Lilac Hills Ranch

Traffic Impact Study

**Roundabout Peer Review
Exhibit of Findings
October 2013**

Project Title:	W Lilac Rd Roundabouts	Design Phase (%):	Conceptual
Owner:	Accretive Investments, Inc.	Date:	October 25, 2013

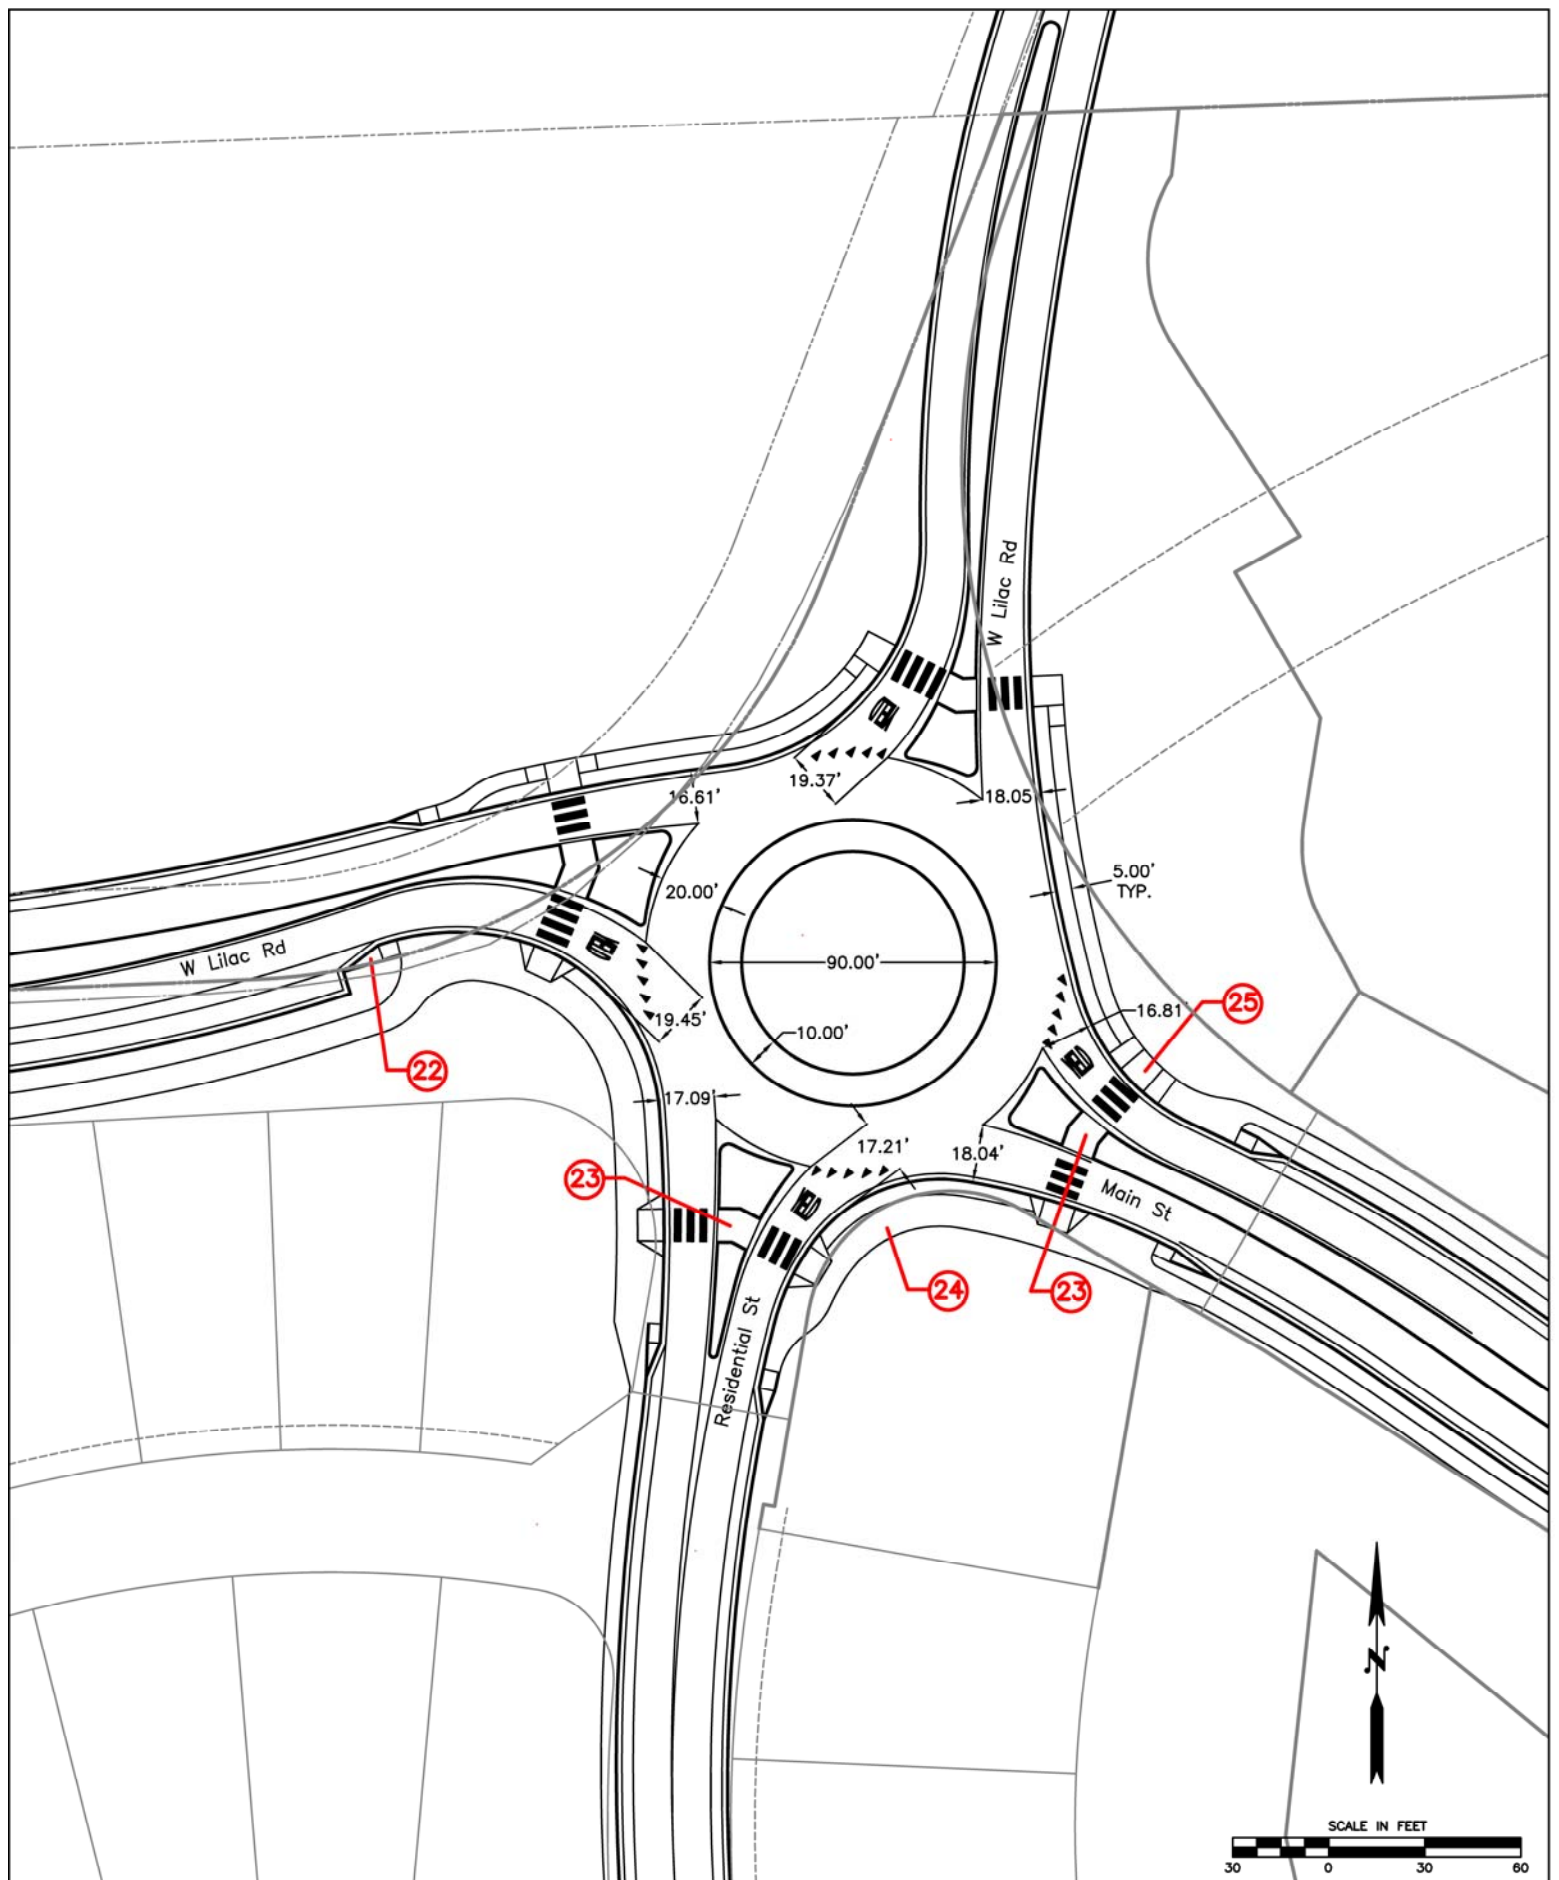
Topic/ Reference	Comment
Item 22 (Figure 3)	Bike ramps are detailed based on RM recommended design. The reasoning behind this type of design can be found in Appendix E.

Item 23 (Figure 3)	Pedestrian refuge islands were designed with equestrian users in mind – the width is a minimum of 10ft.
Item 24 (Figure 3)	Multiuse trail and landscaping buffer widths can be adjusted. (Multiuse trail minimum width is 8ft with 10ft being desirable).

Item 25 (Figure 3)	This type of ramp was used to indicate that all multiuse path users except bicyclists should use this pedestrian crossing and subsequent multiuse paths. The bike path continues around the north side of the roundabout and “bike only” pavement markings could be used. For bicycle users, the path around the north of the roundabout was designed to limit crosswalk exposure for those traveling from Main St to westbound W Lilac Rd (only one crossing versus three if they traverse using the southern multiuse path).

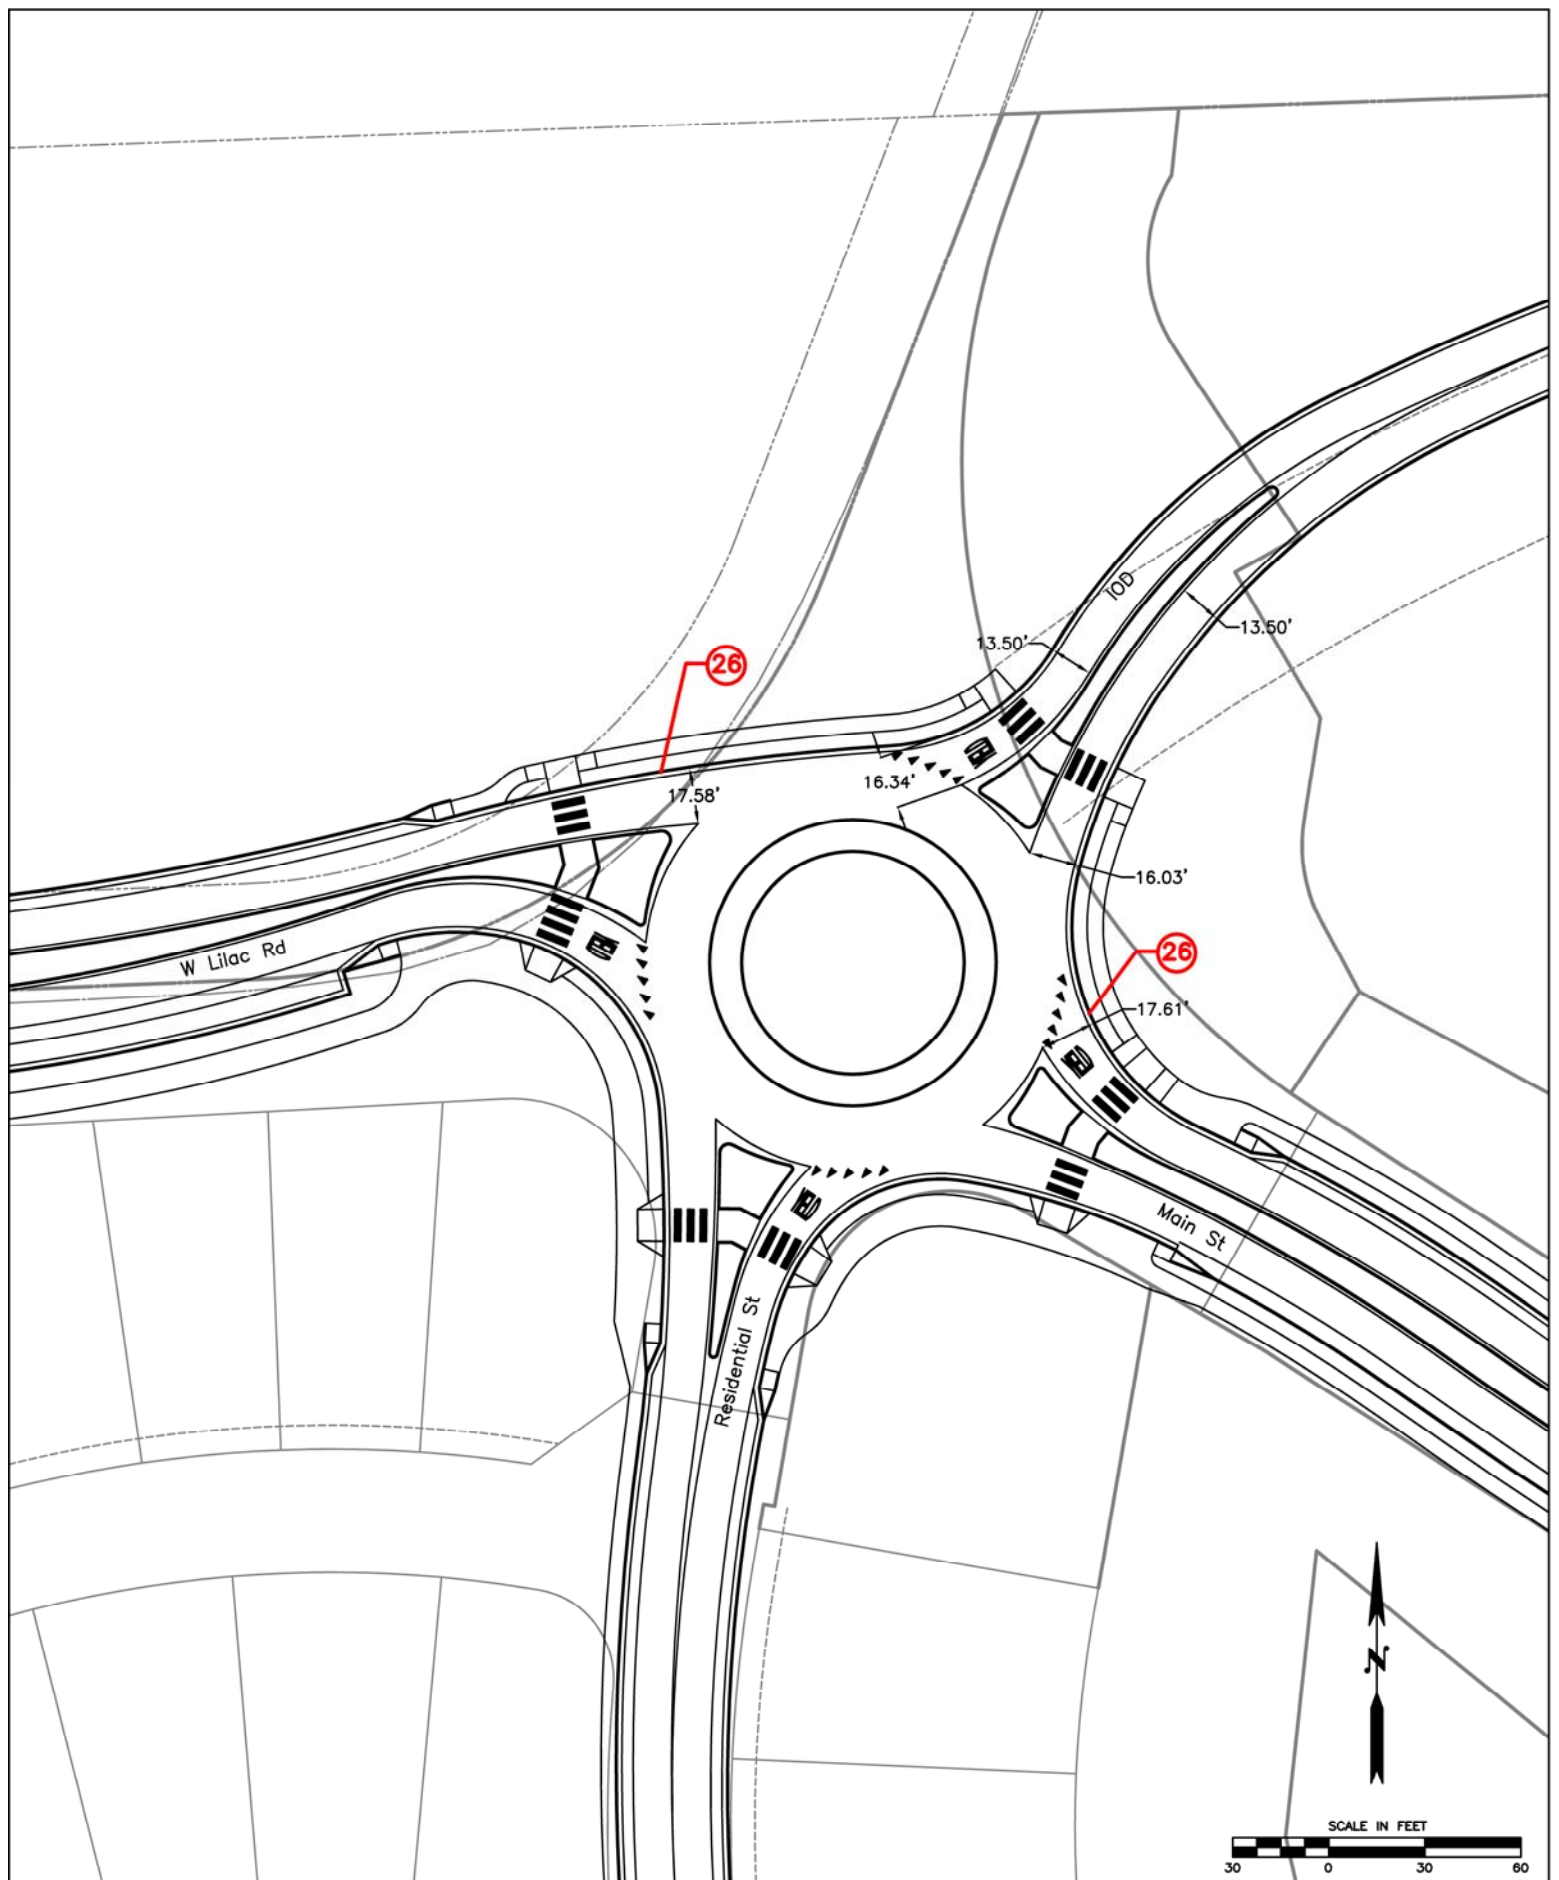
Item 26 (Figure 4)	Entry curvature on Main St and exit curvature on W Lilac Rd changed slightly to accommodate the proposed IOD alignment. All other curb locations remain the same as RB 1.

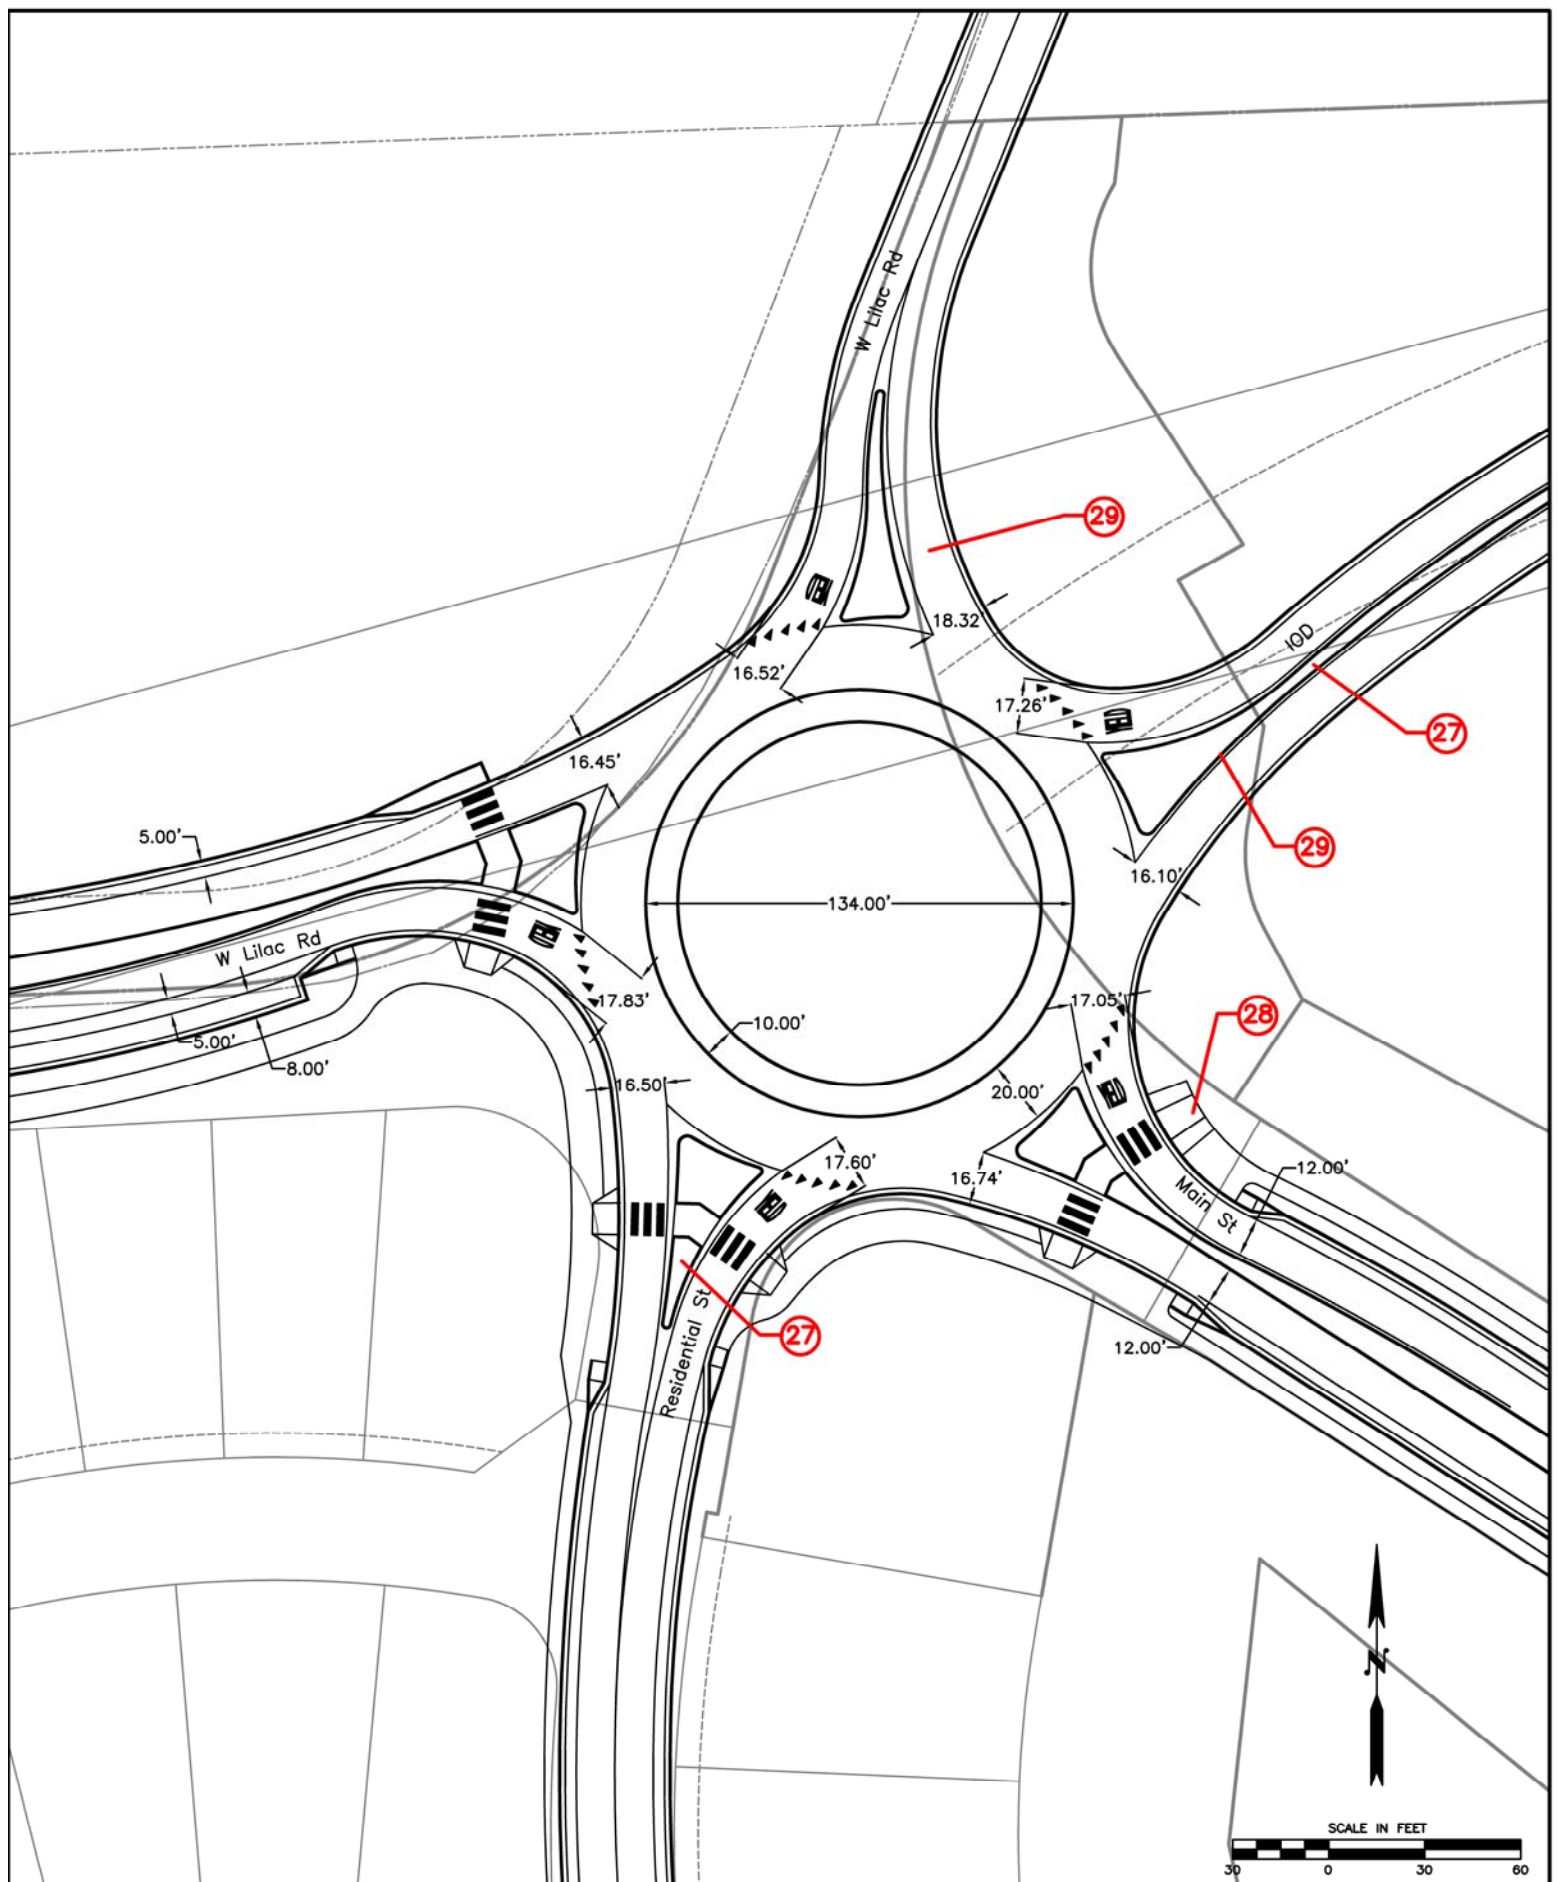
Item 27 (Figure 5)	The splitter island length is influenced by the approach speed. When the approach speed is 30mph a minimum splitter island length of 50ft is acceptable. At higher speeds, the splitter island length increases.

Item 28 (Figure 5)	This type of ramp was used to indicate that all multiuse path users should use this pedestrian crossing and subsequent multiuse paths. Bicyclists are encouraged to use the southern multiuse path system as this route does not substantially increase their crosswalk exposure.

Topic/ Reference	Comment
Item 29 (Figure 5)	This roundabout provides an excellent way of designing for the existing W Lilac Rd, but leaving options open for future IOD alignment development. Residents that live along W Lilac Rd will not have to be inconvenienced with a road closure, and they will not have a negative impact on the roundabout safety or operations. The IOD leg can be built at a later time with no impact to existing roundabout operations.
RM Design RB 2	RM designed a conceptual roundabout, RB 2 that addresses the above concerns of the second intersection. The following item nos. 30-31 correspond to the circular callouts on Figure 6. Appendix B contains all the corresponding back-up calculations for the horizontal geometrics of these RM conceptual roundabouts such as fastest paths, truck turning movements and sight distance requirements.
